DART AEROSPACE LTD		Work Order: 142120
Description: Crosstube High-High Aft		Part Number: D205-596-107
Inspection Dwg: D205-596-107 Rev: B		Page 1 of 1

B	SUPPORT NOW MAGNOBONDED; REMOVE D2856-600-1009 ABRASION STRIP; UPDATED NOTES; ADDED D3595-063-530 CUSHION	MB	07.12.03
A	NEW ISSUE	DS	02.11.20
REV.	DESCRIPTION	BY	DATE
DESIGN	4	DART AEROSPACE LTD HAWKESBURY, ONTARIO, CANADA	
DRAWN	4		
CHECKED	PH	DRAWING NO.	REV. B
MFG. APPR.	4	D205-596-107	SHEET 1 OF 2
APPROVED	4	TITLE	SCALE
DE APPR.	4	CROSSTUBE ASSEMBLY, HI-HI AFT	NTS
DATE	07.12.03	COPYRIGHT © 2002 BY DART AEROSPACE LTD THIS DOCUMENT IS PRIVATE AND CONFIDENTIAL AND IS SUPPLIED ON THE EXPRESS CONDITION THAT IT IS NOT TO BE USED FOR ANY PURPOSE OR COPIED OR COMMUNICATED TO ANY OTHER PERSON WITHOUT WRITTEN PERMISSION FROM DART AEROSPACE LTD.

DRAWING NO. D205-596-107	TITLE CROSSTUBE ASS'Y, HI-HI AFT	REV. B	DART AEROSPACE LTD ENGINEERING ORDER		D.E.O. NO. D205-596-107-B-2	SHEET NO. SHEET 1 OF 1	SCALE NTS
DRAWN <i>MP</i>	CHECKED <i>A.P.</i>		MFG. APPR. <i>AA</i>	APPROVED <i>MP</i>	DE APPR. <i>MP</i>		
DATE 13.11.11	DATE 13.11.14		DATE 13.11.19	DATE 13/11/21	DATE 13/11/21

DRAWING NO. D205-596-107	TITLE CROSSTUBE	REV. B	DART AEROSPACE

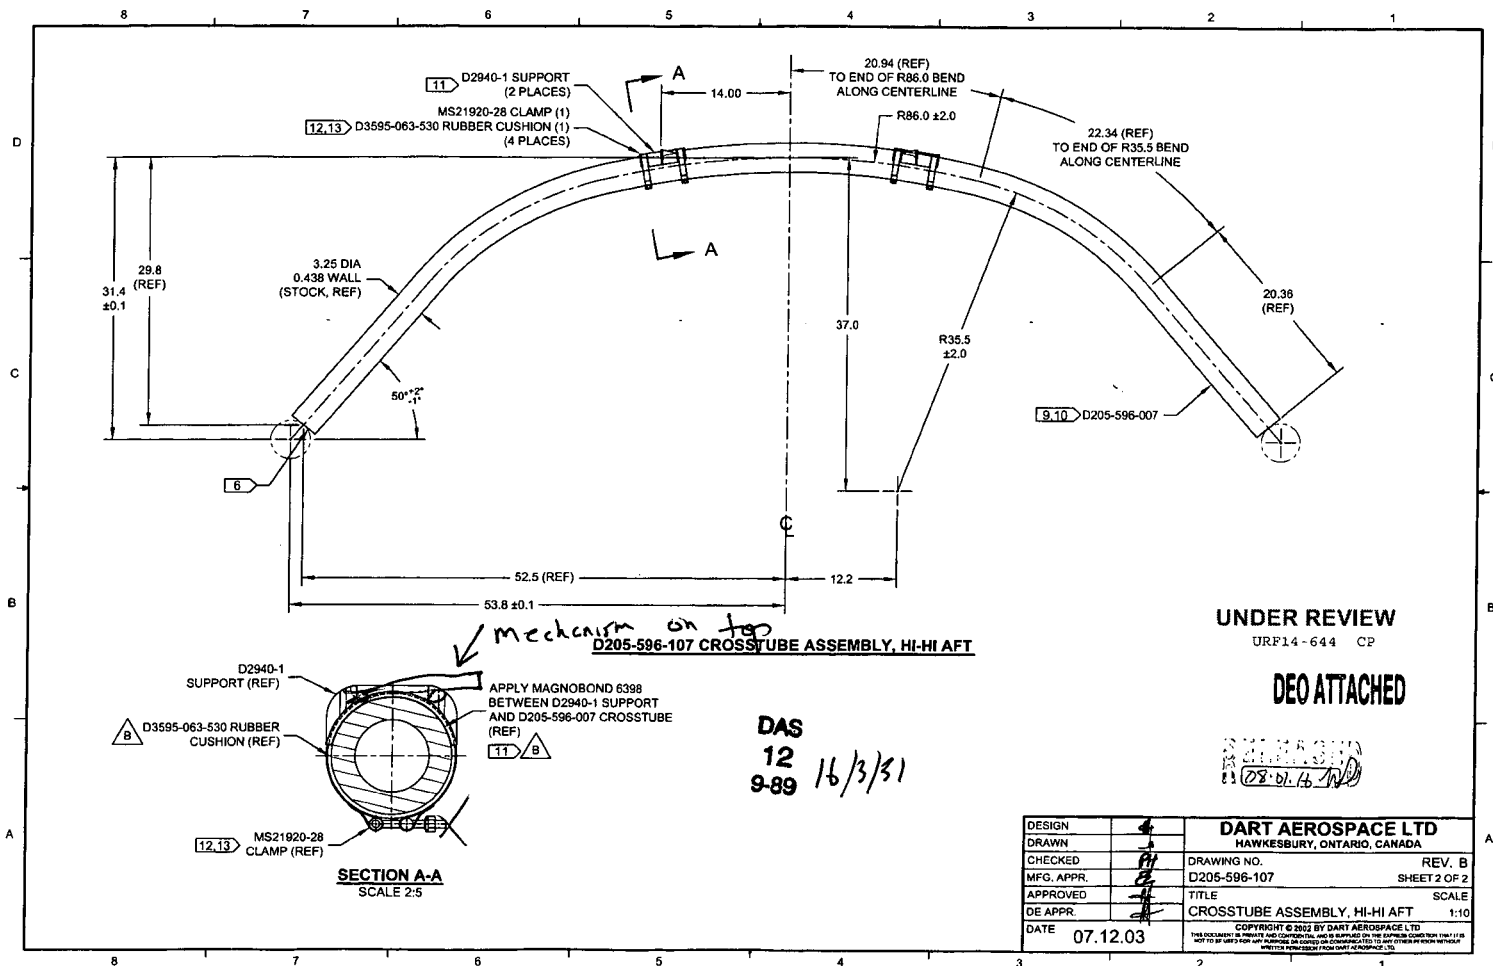
PURPOSE:
REPLACE MAGNOBOND WITH PROSEAL.

NOTE 11 & 13, SHEET 1 IS AMENDED AS FOLLOWS:

- 11) TO INSTALL D2940-1 SUPPORT: ABRABE MATING SURFACE OF SUPPORT AND CROSSTUBE WITH 180-GRIT SANDPAPER AND REMOVE RESIDUE WITH MEK (OR EQUIVALENT). APPLY A 0.04" TO 0.07" THICK LAYER OF PROSEAL 890 CLASS B-2 (OR AMS-S-8802 CLASS B-2) SEALANT TO MATING SURFACE OF SUPPORT.
- 13) TORQUE CLAMPS 80 TO 100 IN-LB. ENSURE AT LEAST 1.5 THREADS SHOWING IN SAFETY AND THAT NUT HAS NOT BOTTOMED-OUT AFTER TORQUING. PRIOR TO PACKAGING, RE-CHECK TORQUE ON CLAMPS AFTER PROSEAL 890 SEALANT HAS CURED FOR 72 HOURS.

- 11) APPLY A 0.03" TO 0.06" THICK LAYER OF MAGNOBOND 6398 TO THE SURFACE OF D2940-1 THAT WILL BE IN CONTACT WITH THE CROSSTUBE. LET CURE FOR 12 HOURS AFTER INSTALLATION AND PRIOR TO PACKAGING.
- 13) TORQUE CLAMPS 80 TO 100 IN-LB.

FIGURE 1 - SUPPORT INSTALLATION

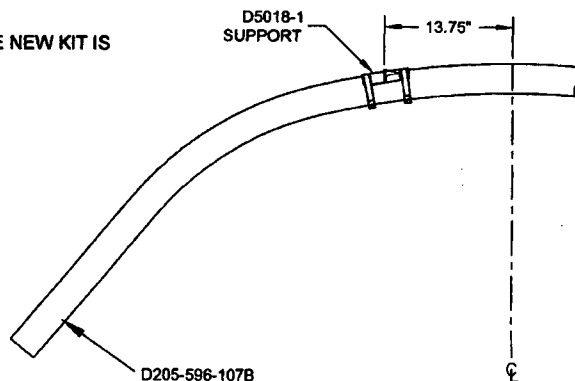
ADD THE FOLLOWING CROSSTUBE ASSEMBLY:

THE D205-596-107B CROSSTUBE HAS THE SAME PARTS LIST AS THE D205-596-107 CROSSTUBE EXCEPT AS FOLLOWS:

2	D5018-1	SUPPORT
---	---------	---------

INSTALL THE SUPPORTS AS SHOWN IN FIGURE 1 OF THIS ENGINEERING ORDER. THE NEW KIT IS OTHERWISE ASSEMBLED PER THE D205-596-107 CROSSTUBE.
